TECHNICAL BULLETIN

206-12-199  
2 February 2012

**MODEL AFFECTED:** 206A/B

**SUBJECT:** IMPROVED UPPER LEFT LONGERON/FITTING ASSEMBLY P/N 206-031-314-223A AND AFT FUSELAGE BULKHEAD 407-030-027-105, INTRODUCTION OF.

**Figure 1: Installation of L/H Upper Longeron (sheet 1 of 7)**

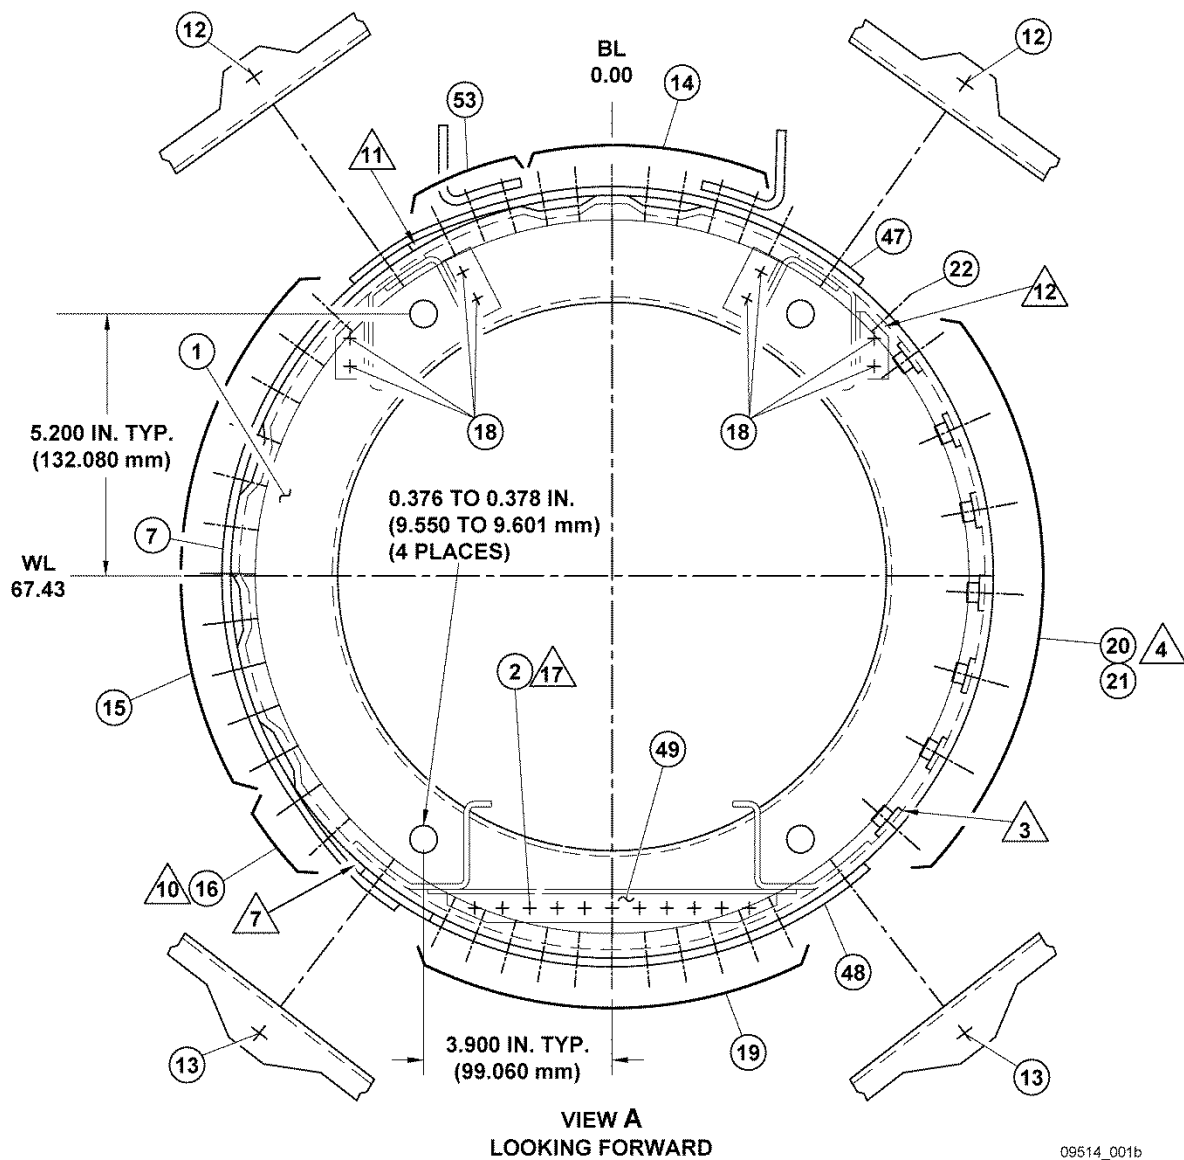
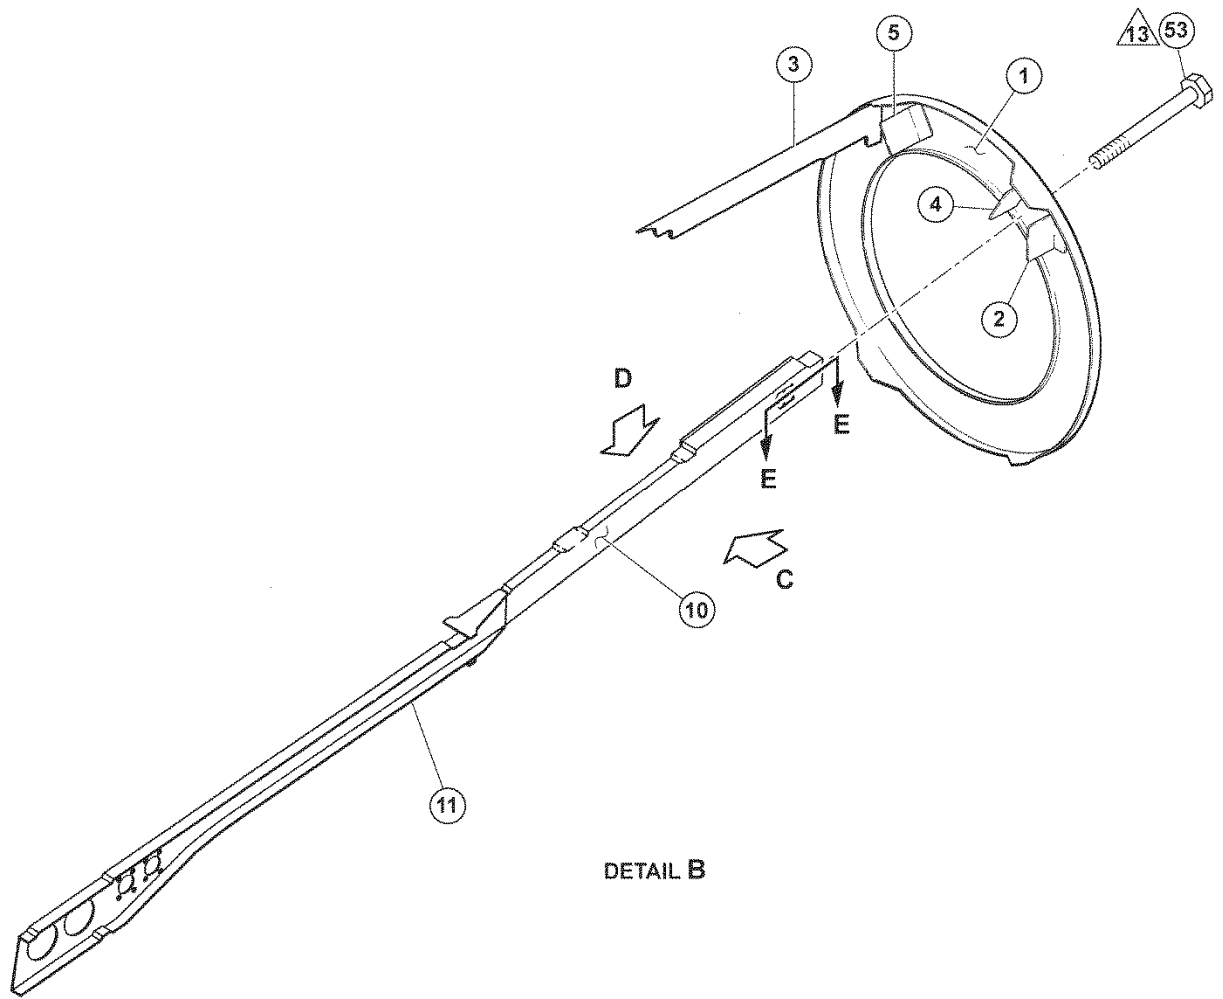
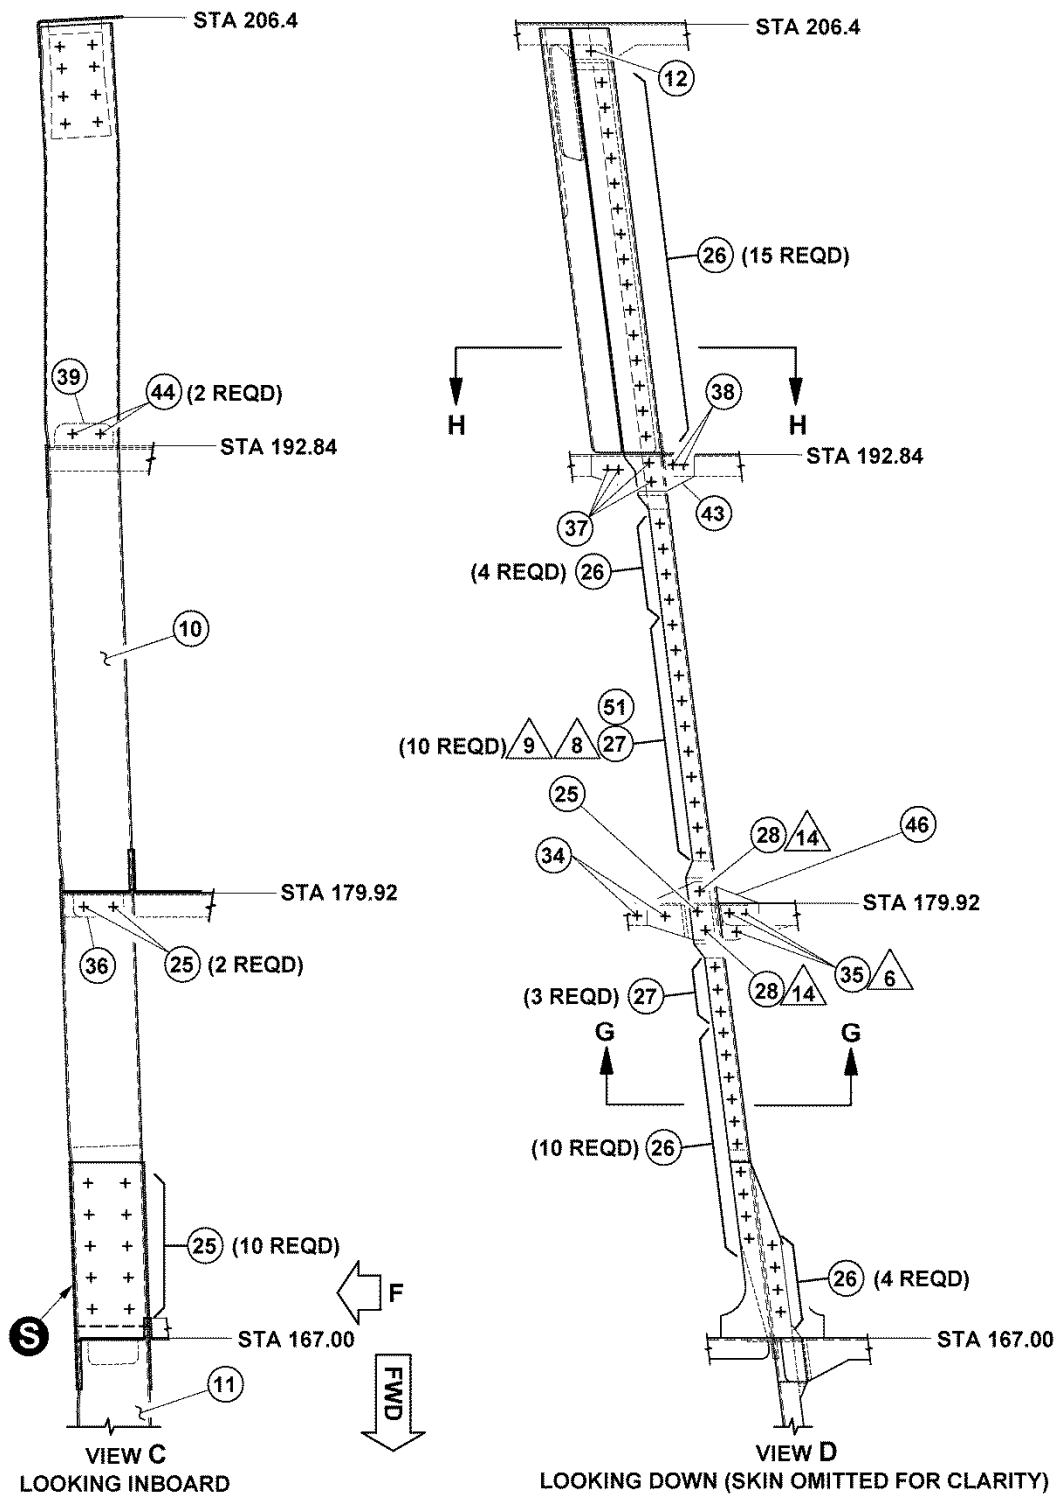
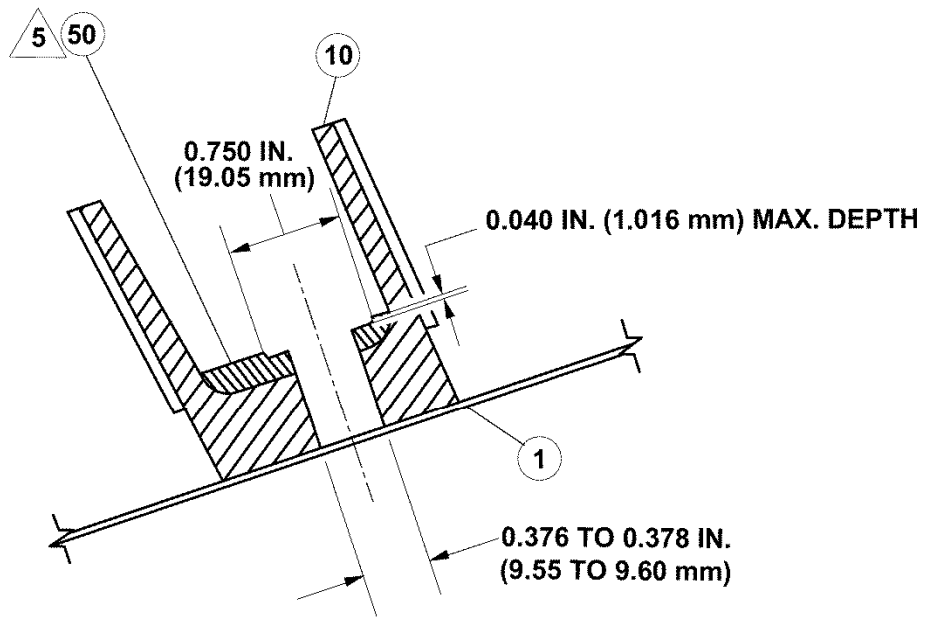
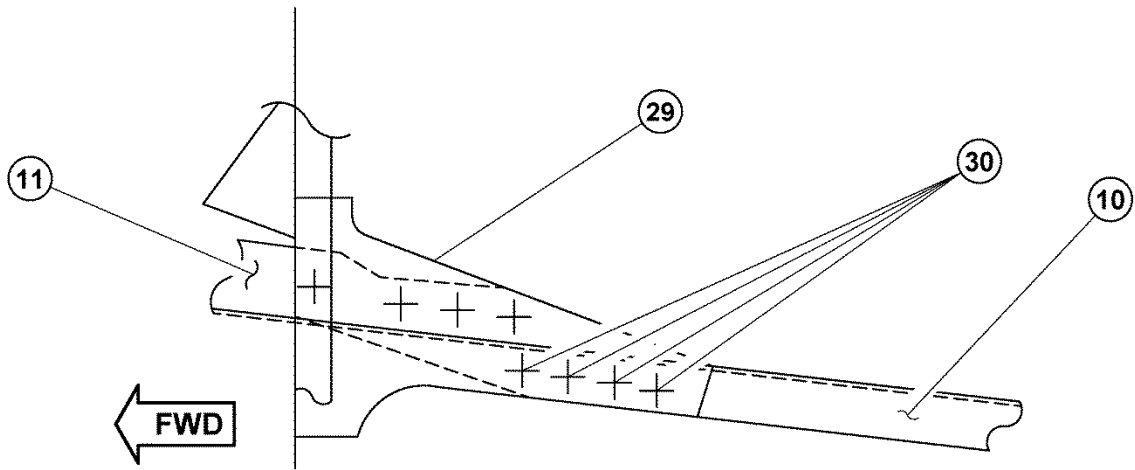
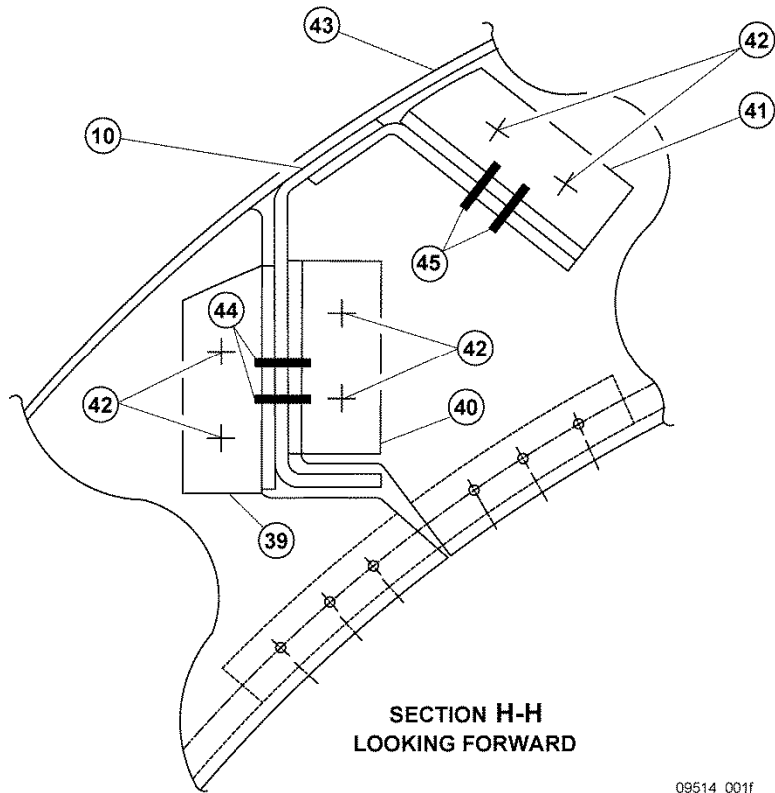
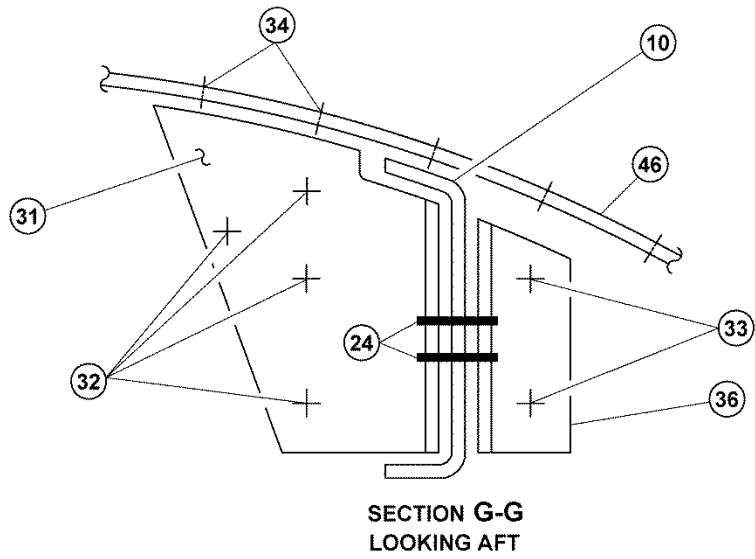
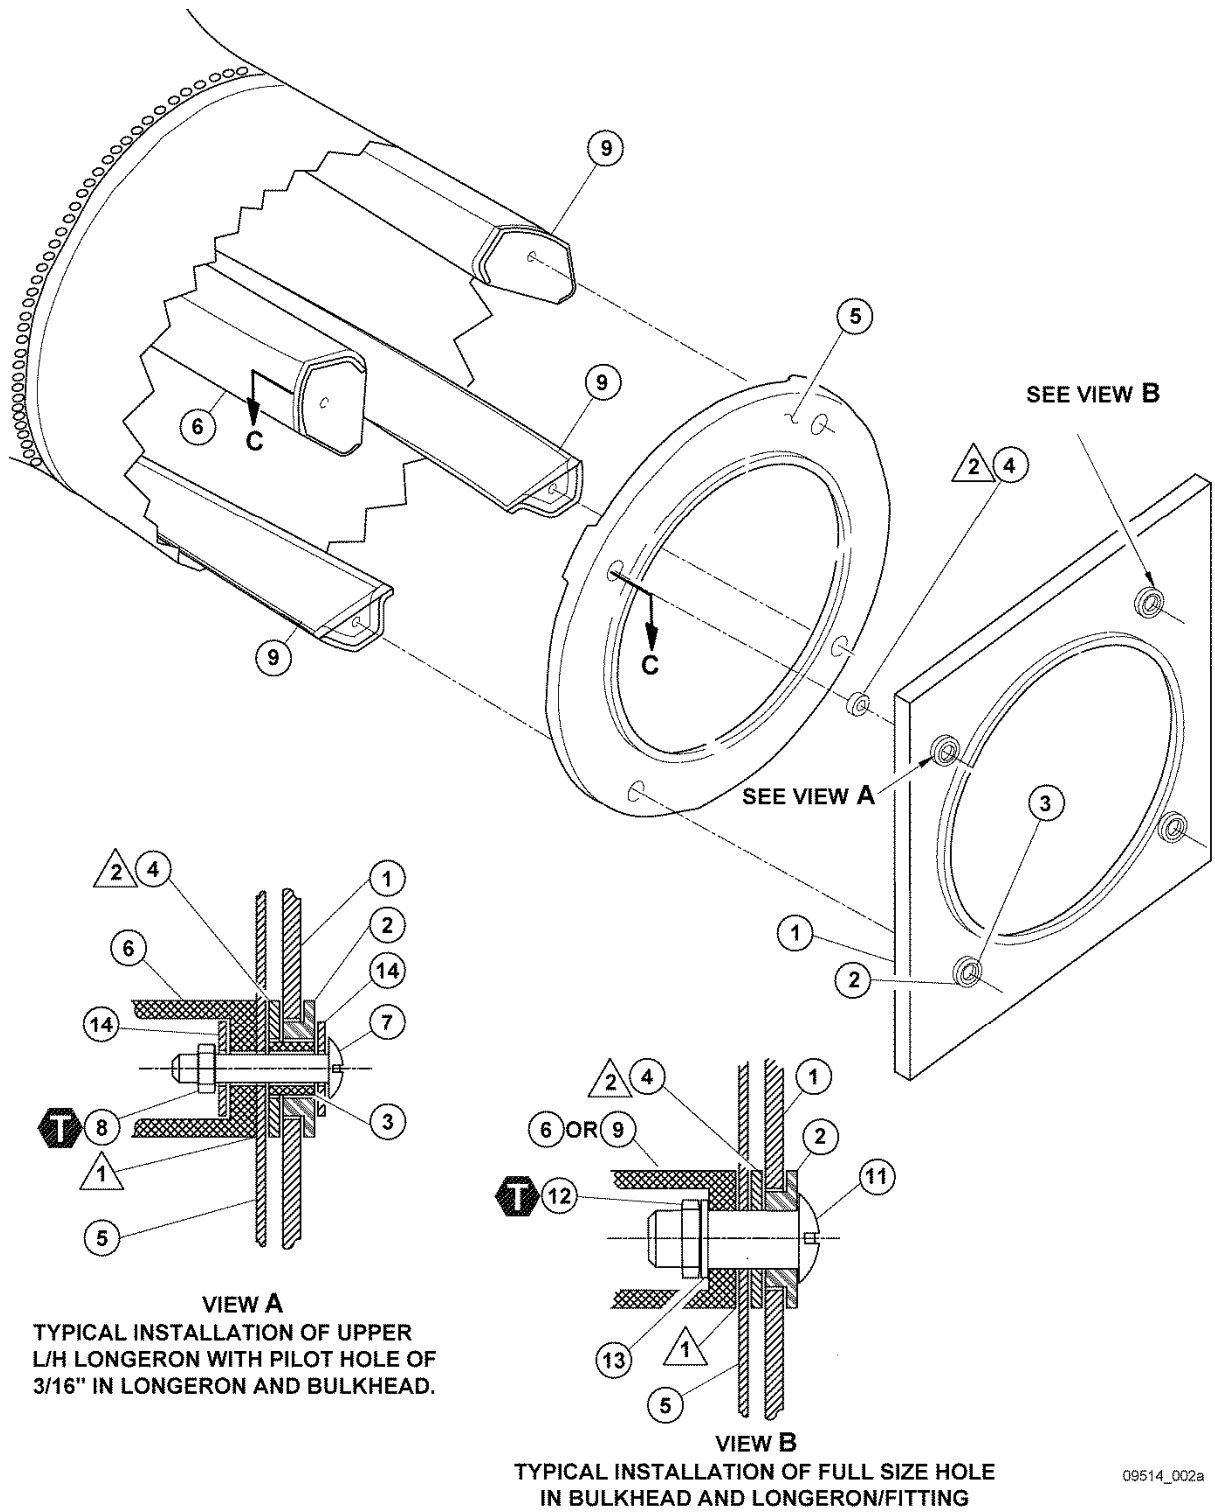
9. Record type, size and location of the rivets securing skin (7) or (9) before drilling. Use care to break sealant and remove skin (7) or (9).
10. Refer to Figure 1, View C, View D, View F-F, and View G-G and remove fasteners securing the aft longeron (10) located between FS 167.00 and 206.4.
11. Remove sealant from faying surfaces of all parts.
12. Carry out a first fit check on the new replacement longeron (10) in place in the aft fuselage. Make sure adequate edge distance exists at all places. If the position of the upcoming fasteners in the longeron (10) are all acceptable at all locations, keep the longeron (10) in place in aft fuselage.
13. Temporarily install bulkhead (1, Detail B) into position.

15. Position the forward portion of the longeron (10) to ensure that the top surface of the longeron (10) is tight against the upper surface of bulkhead (1) and the upper skin (47). Temporarily clamp aft longeron (10) to the forward longeron (11). Mark all rivet holes, using a felt pen, including the lower skin (47) and doubler (29, View F-F).

19. At STA 167.00, transfer 10 rivet holes from the forward longeron (11, View C). Transfer 4 rivet holes (30, View F-F) from splice doubler (29) to lower flange of longeron (10). At STA179.92, transfer 2 rivet holes from clip (36, View G-G).

20. At STA 192.81, transfer 2 rivet holes from clip (39, View H-H) and clip (41) to side of longeron (10) and secure with clecos.
21. Transfer rivet holes from splices (43 and 46, View D) to upper flange of longeron (10).

22. Temporarily install skin (7) and (9) with clecos. Transfer all rivets holes from skins (7, 9 and 47) to upper flange of longeron (10) and secure with clecos.
23. Transfer rivet hole (12, View A) from flange of bulkhead (1) to longeron (10). Transfer 4 rivets holes (18) from bulkhead (1) to clips (2 and 4, Detail B).

As an alternate to hot dimpling the longeron (10) at the location for the 10 flush rivets (27, View D), it is acceptable to use new skins (7 and 47) and do countersunk holes in skin (47) only. Install new L/H aft skin (7) and new upper skin (47) with 10 shallow head type rivets (51, View D) in lieu of standard flush rivets (27). Countersink upper skin (47) only to suit rivet (51). Do not perform Step 25.

25. Dimple 10 rivet holes (27) using hot dimple process (BHT-ALL-SRM, Chapter 3).
26. Brush coat mating faces of longeron (11, View C) and longeron (10) with sealant (C-392). Install longeron (10) into place with clecos. Do not install skin (7) at this time.
27. Reinstall bulkhead (5, Figure 2) with clecos. Attach drill plate (1) with 3/16 size bolt (7, View A) at the new longeron/fitting assembly (6). Attach drill plate (1, View B) to the three other fittings (9) with bolt (11) and nut (12) **T**.
28. Refer to Figure 1, View C, View D, View F-F, View G-G, and View H-H and use fasteners (25, 30, 32, 33, 34, 42, 44, and 45, Figure 1) for securing the aft longeron (11), doubler (29), clips (31 and 36), and clips (39, 40 and 41), located between FS 167.00 and 206.4.
29. Apply sealant (C-392) to all faying surfaces of the fuselage skins (7, 9 and 47).

30. Do not install rivets for retainer (6) at this time. Secure skins (7, 9 and 47) to longeron (10) with rivets (25 and 26, View D).
31. Brush coat mating surface of retainer (6) with sealant (C-392). Install retainer (6) on top of skin (9) and (47). Secure retainer (6) to skins (9) (47) and to the longeron (10) with same type of rivets recorded before their removal. Do not install the rivets through bulkhead (1) at this time.
32. Install all remaining rivets through skin (7 and 9) using same type of rivets recorded before their removal.

Figure 2. Installation of Drill Plate (Sheet 1 of 2)

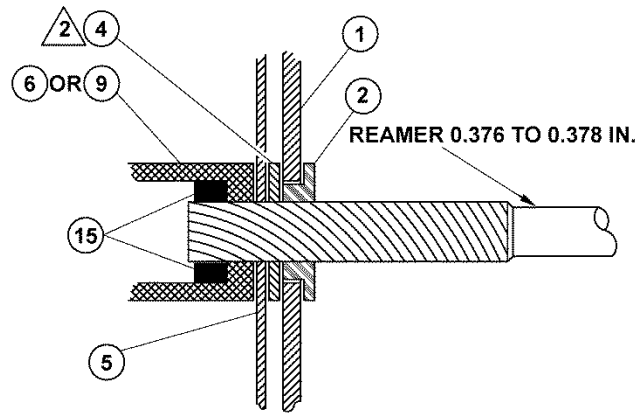
- a) Position the drill plate (1) against the aft fuselage bulkhead (5) at this time using all four bolts (11).
  - b) The bolt (11) at each position should move freely without any binding or interference while the other 3 are installed in the adjacent fittings.
  - c) If interference exists at any of the four fitting locations, contact Product Support Engineering for assistance.
  - d) If each hole in the fuselage-to-tailboom attachment fitting matches the drill plate (1) without any interference, remove the drill plate (1) and proceed to Step 6.
6. Remove the aft fuselage bulkhead (1, Detail B, Figure 1) in accordance with procedure in the 6-2-13 of the SRM (BHT-206-SRM-1).
7. Verify that the four longeron/fittings (6 and 9, Figure 2) are in plane within 0.002 inch.

- a. Position the drill plate (1) against all four tailboom attachment fittings (6 and 9) and insert the four bolts (11) through each fitting (6 and 9). Do not install the nut (12) and washers (13).
- b. With a filler gauge verify if there is gap between fittings (6 and 9) and plate (1). Gap must not exceed 0.002 inch (0.050 mm).
- c. If one of the fittings (6 and 9) has a gap in excess of a 0.002 inch (0.050 mm), stop process and contact Product Support Engineering with details for further assistance.
- d. If the gap is within limit, install washer (13) and nut (12)  and proceed to Step 8.

14. Temporarily secure the drill plate (1, Figure 2) to the R/H upper longeron/fitting and both lower longeron/fittings (9, Figure 2, View D) using bolts (11), washer (13) and nuts (12) **T**. A stack of washers (13) might be required to ensure that grip length is adequate. Attach the drill plate (1) to the new longeron/fitting assembly (6, View A) with 3/16 size bolt (7) and nut (8) through existing 3/16 inch pilot hole already drilled in the longeron/fitting (6) **T**. Verify there is no gap at four locations between longeron/fittings (6 and 9) and bulkhead (5).

33. Secure aft bulkhead (1, View A) to aft fuselage.
34. Remove bolt (7, Figure 2, View A) and nut (8) from upper L/H upper longeron/fitting (6). Remove bushing (3).

35. Enlarge hole until you can final ream to 0.376 to 0.378 inch (9.55 and 9.60 mm) in diameter through bulkhead (5, Figure 2, View C), longeron/fitting (6) and bonded radius block (15).
36. Spotface to 0.750 inch diameter the forward surface of the radius block (50, Figure 1) deep enough to obtain a constant flat surface. Maximum depth of the spotface not to exceed 0.040 inch.
37. Remove drill plate (1, Figure 2) from aft fuselage. Deburr and clean the hole and the spotface in the L/H upper longeron/fitting (6).
